Service description

Product: VM450	Service description no: 4121-S001	Ver: 1
-------------------	---	-----------

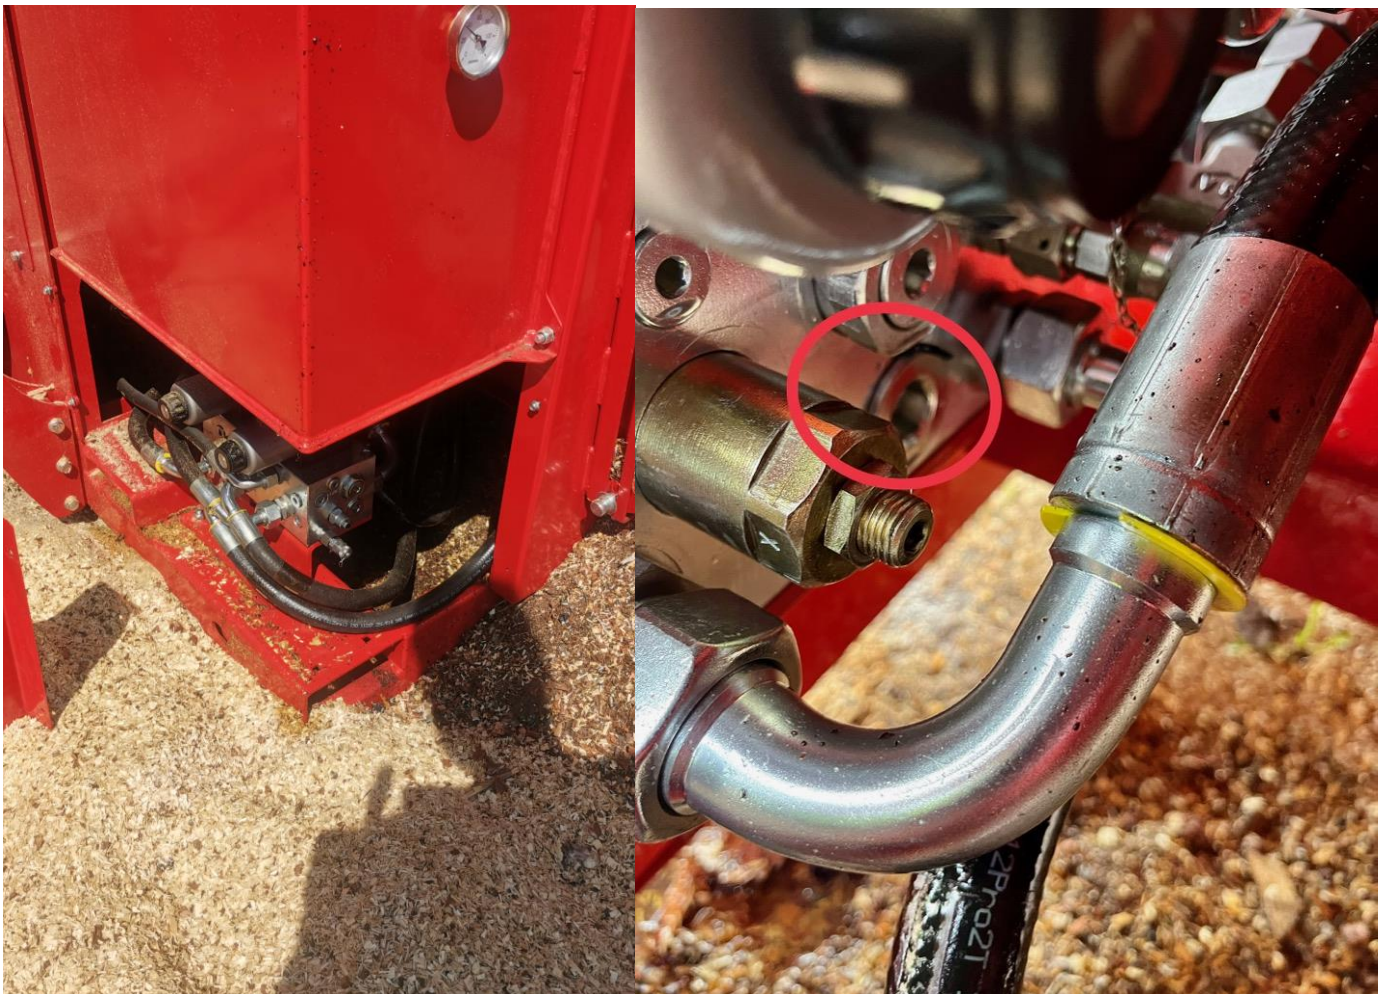
Leakage on the block under the oil tank. Regenerative block.

The O-ring is blown out because the plug in the block is too long and the threads go down before the O-ring is compressed.

Put in a new plug.

1. Release the hose connection as shown in the picture, and rotate the hose that you could reach the plug with the tool. Do not remove the hose as this will cause a lot of oil leakage.

2. Unscrew the plug with a 17 mm unbrako.

3. Screw in a new plug with o-ring and fasten the hose.
